CITY OF KIRKLAND
2024 STREET OVERLY PROJECT
JOB NO. 09-24-PW NO. STC0060024/STC0060324
ADDENDUM NO. 1

TO THE PLANS, SPECIFICATIONS, PROPOSAL AND CONTRACT

Issued This Date: Tuesday, June 13, 2024
Bid Opening: **Unchanged – June 18, 2024**
Place of Opening: City Hall, Peter Kirk Room, posted online

SHEET 6 OF 53 SHEETS

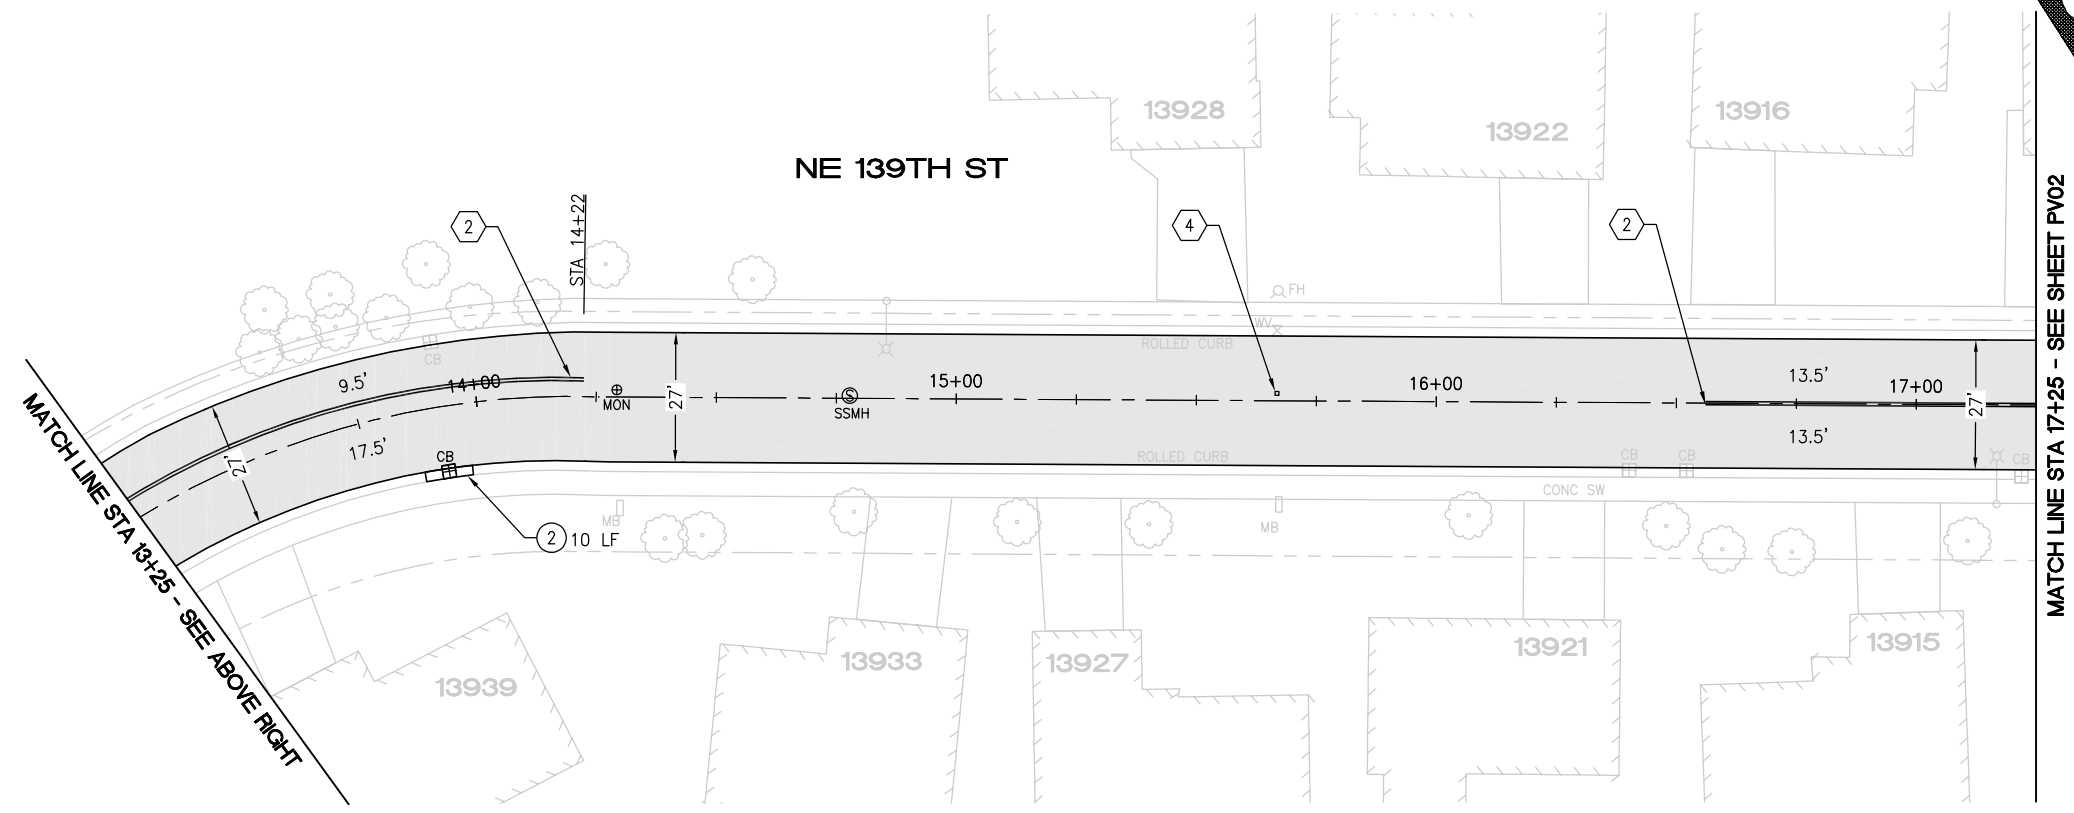
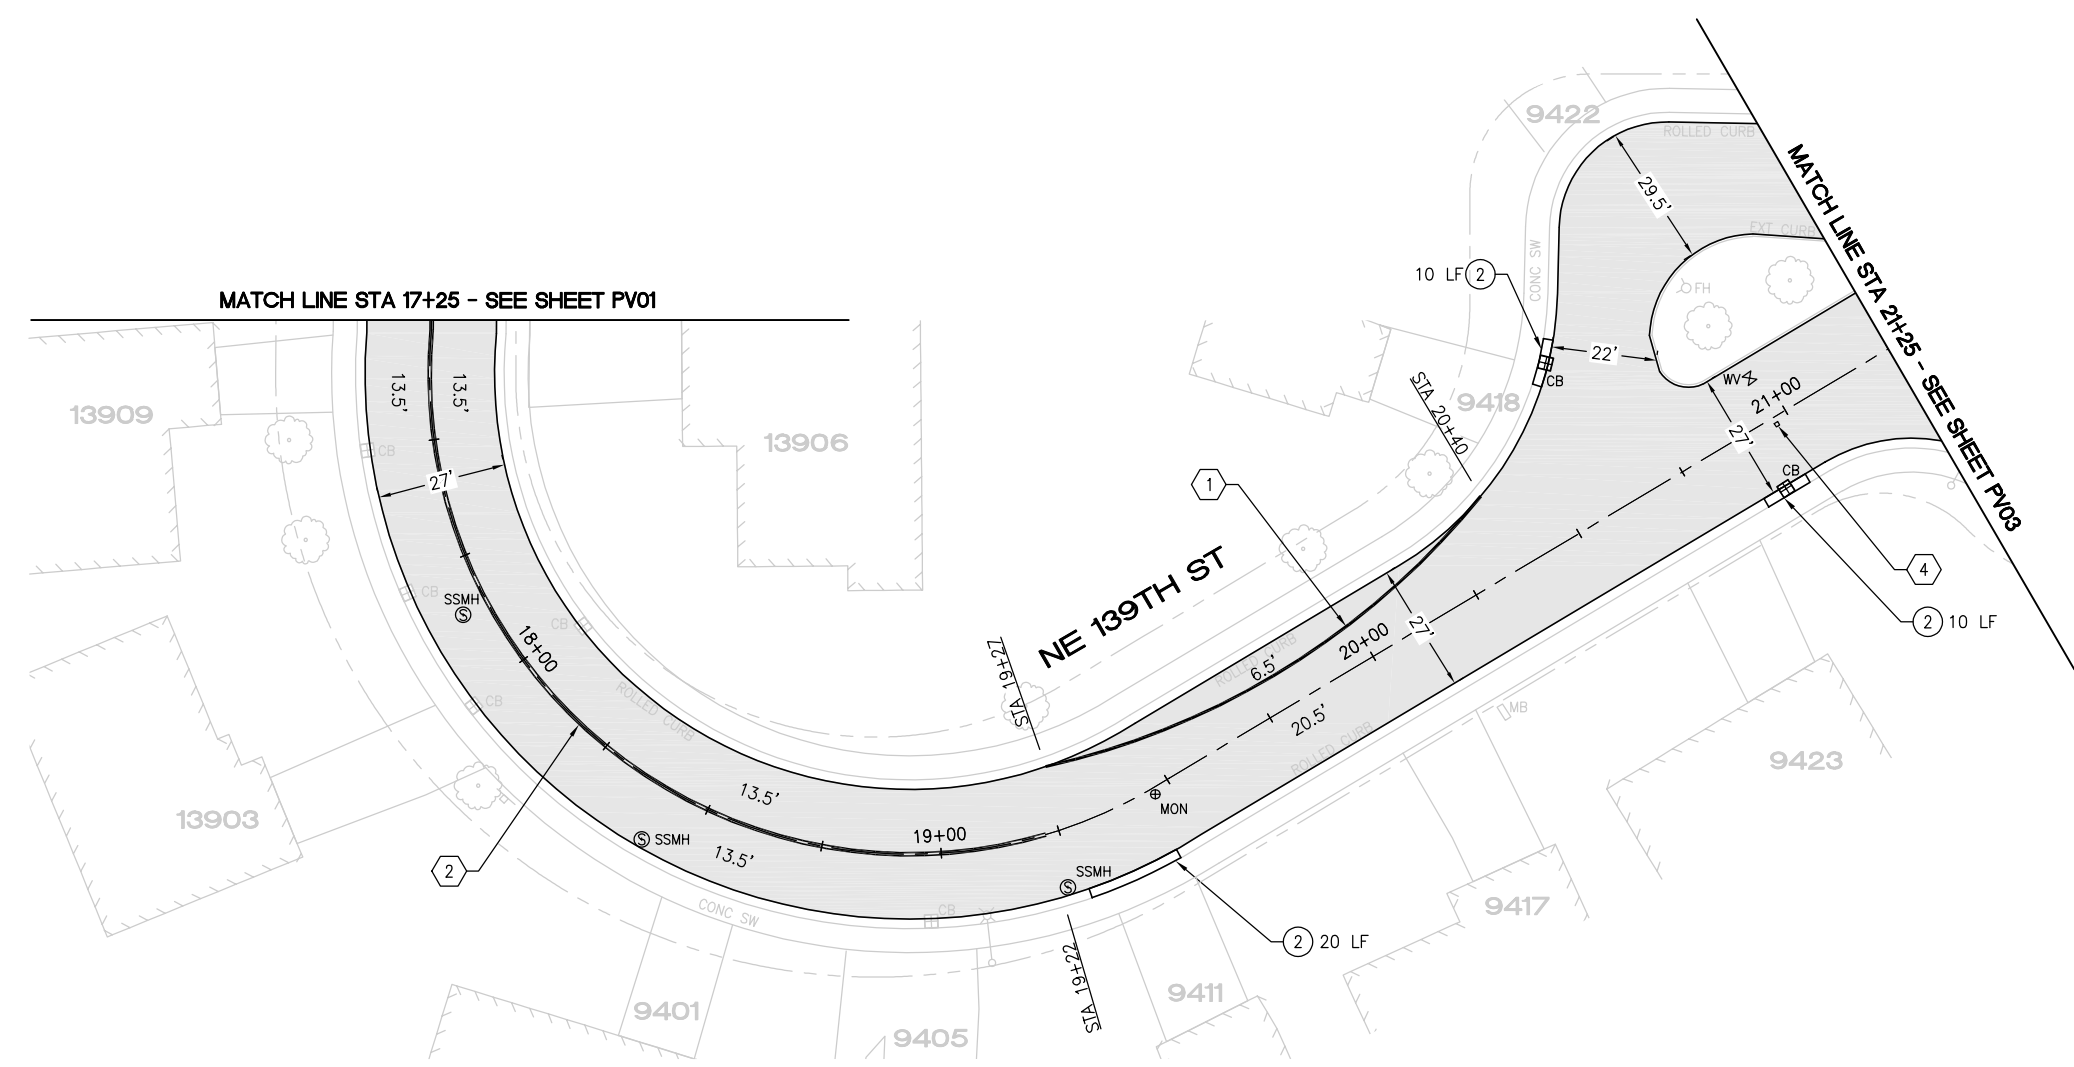
- Plan Sheets 6,7,8: The following note has been added "ROADWAY EXCAVATION INCL HAUL (APPROX. 1")"
- Plan Sheet 9: The following note has been removed "ROADWAY EXCAVATION INCL HAUL (APPROX. 1")"

- REMOVE EX HMA FULL WIDTH, FULL DEPTH (APPROX 2")
- ROADWAY EXCAVATION INCL HAUL (APPROX. 1")
- COMPACT EX SUBGRADE TO 95%
- REPLACE WITH 3" HMA CLASS 1/2"
